May 11, 2022

RE: Comments on Draft EAs for R5 Post-Disturbance Hazardous Tree Management Project

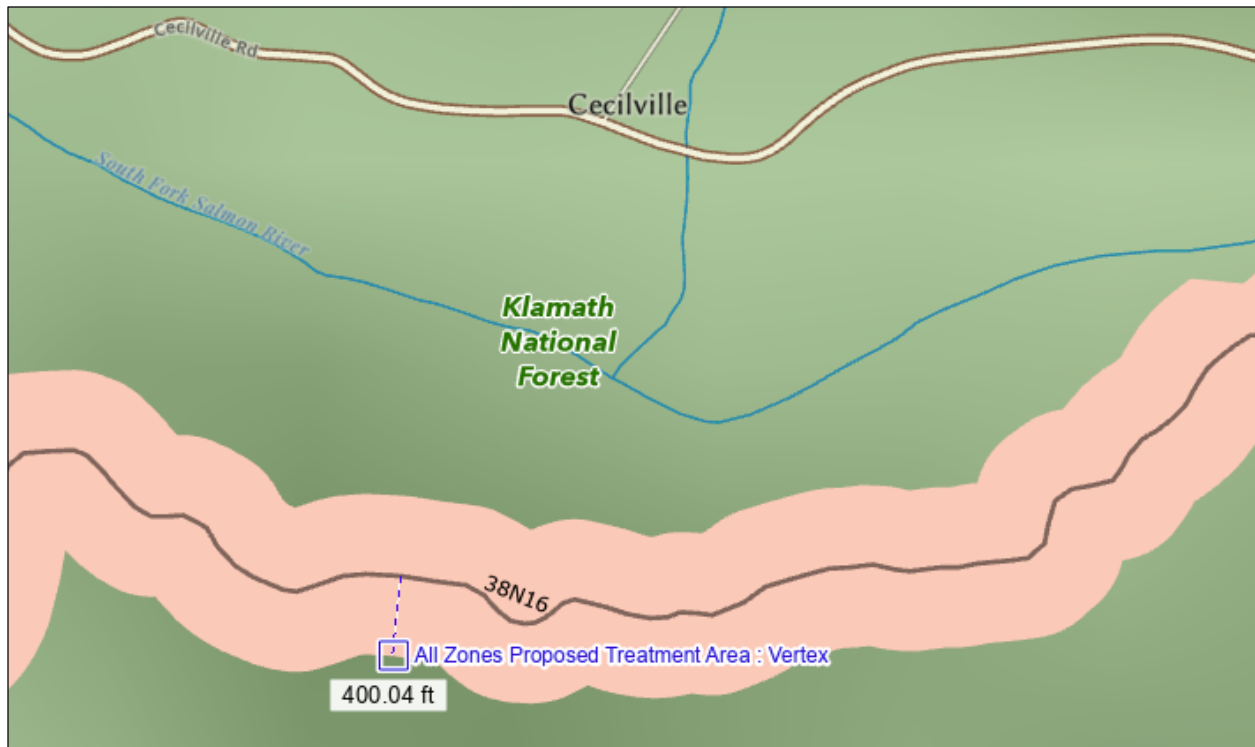
Throughout the EAs and supporting documents, the Forest Service consistently describes the treatment areas as being within 300 feet of selected features. However, the project's underlying GIS data for all three zones depict treatment areas that are within 400 feet of the centerline of roads and trails (an 800-foot corridor), and around facilities and infrastructure (see Map 1).<sup>1</sup> This is 33% larger than described in the text of the EAs and supporting documents.

As such, the actual geographic extent of the proposed project is unclear. Is it 300 feet each side of selected roads, trails, and other features as the narrative text states or is it 400 feet each side as indicated by the GIS data and its derivative geospatial and quantitative analyses that are in the EAs and supporting documents?

This is a significant and foundational discrepancy that must be corrected. Because many, if not all, of the geospatial and quantitative analyses in the EAs and specialist reports utilize the GIS data with the 400-foot buffer, re-analyzing the project with the project’s stated 300-foot buffer will substantially change the content of the analyses, and it may be necessary to circulate corrected draft EAs for public comment.

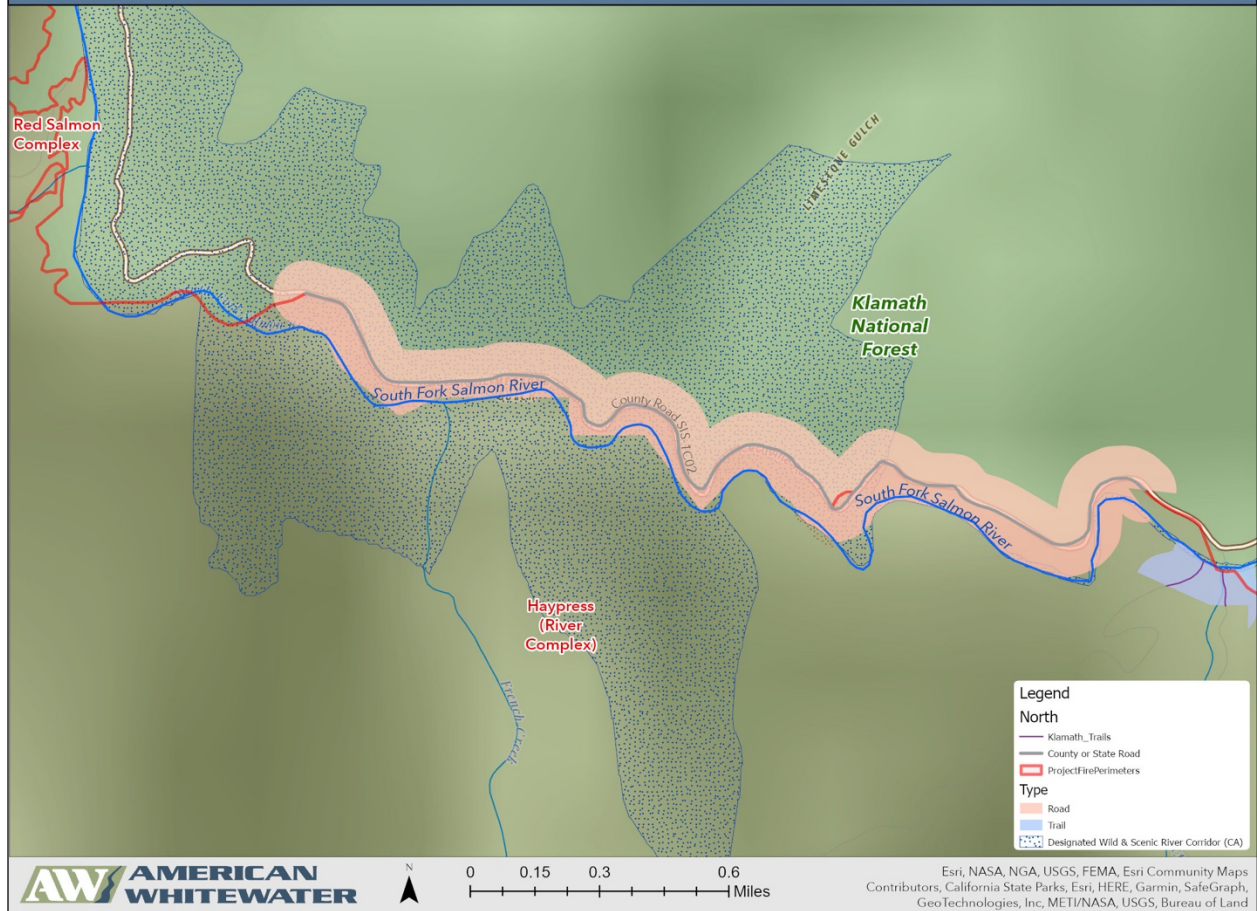
There is an error in the mapping of the northern edge of the 2021 Haypress Fire (River Complex) on the Klamath National Forest about 2.5 miles west of Cecilville, California along the South Fork Salmon River. The fire was contained along the south bank of the river but the fire perimeter polygon incorrectly shows the fire as having been contained along Cecilville Road (County Road SIS-1C02). The road is 200-500 feet to the north and uphill of the river. It appears that this mapping error occurred during the wildfire suppression effort, and it has not yet been corrected.

As a result of this error and the apparent lack of any ground-truthing of proposed treatment units, the Forest Service has proposed a sizable treatment area along Cecilville Road in an area that is entirely unaffected by recent fire (see Map 2 and Photo 1). The treatment area is located along a more than one mile of designated Wild and Scenic River and along a scenic roadway. There are no fire-killed or damaged trees in this treatment area because the fire did not burn within it, except for the approximately 6 acres that are located on the south side of the South Fork Salmon River.

The purpose of the project is to address post-disturbance hazard trees. Because there was no disturbance within this proposed treatment area and no hazard trees as a result, the unit should be removed from the project.
